Access Compliance Report

Public Rights-of-Way

(Pedestrian Signals)

Intersection ID: N/A	Main Street:	Cross Street: N/A	Location: N/A
ADA ID: 4FFA0CF470E0	Signal Type: Two Push Buttons-APS	Overall Compliance: No	Severity Score: BTN 1:N/A BTN 2: N/A No BTN: N/A
Codes/Mitigation Info/Possible Solution		Field Measurements/Component Compliance

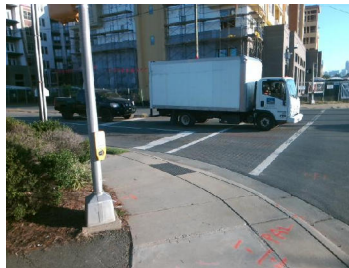
Possible Solutions: Replace Signal Push Button With APS Button on New Post. Remove & Relocate Sign.

PROW/ADA: TMUTCD 4e.08, R404.2, R406.2, R404.7.3, R209.1, MUTCD 4e.10, R104.2,
